Product Change Notification / ASER-15CAKZ286

CCB 4630.001 Initial Notice: Qualification of STA as an additional assembly site for selected CAP1188 and USB33xx device families available in 24L VQFN (4x4x0.9mm) package.

CCB 4630.001
Pre and Post Change Summary
PCN #: ASER-15CAKZ286

Lead frame Comparison

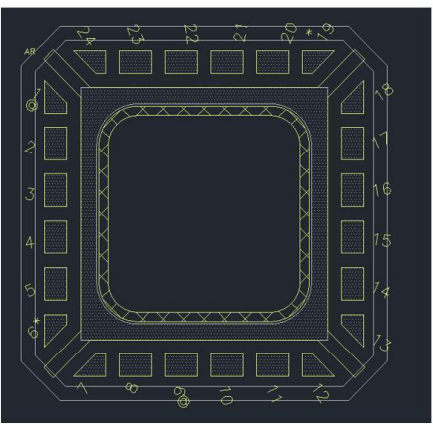
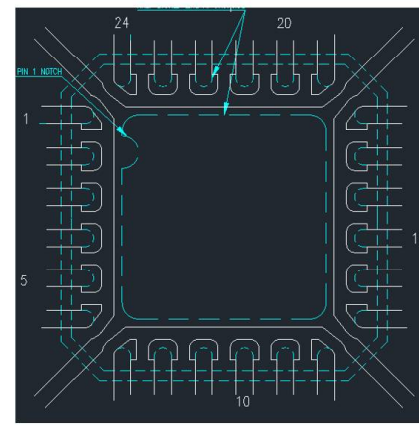
**Qualification of STA as an additional assembly site for selected
CAP1188 and USB33xx device families available in 24L VQFN
(4x4x0.9mm) package.**

ASE	STA
<p data-bbox="360 840 505 873">ASEK</p>  <p>The ASEK layout diagram shows a square chip with a central square core. The core is surrounded by a ring of memory blocks, which are further surrounded by a ring of logic blocks. The layout is symmetrical and includes a central square core.</p>	<p data-bbox="1117 840 1263 873">STA</p>  <p>The STA layout diagram shows a square chip with a central square core. The core is surrounded by a ring of memory blocks, which are further surrounded by a ring of logic blocks. The layout is symmetrical and includes a central square core.</p>
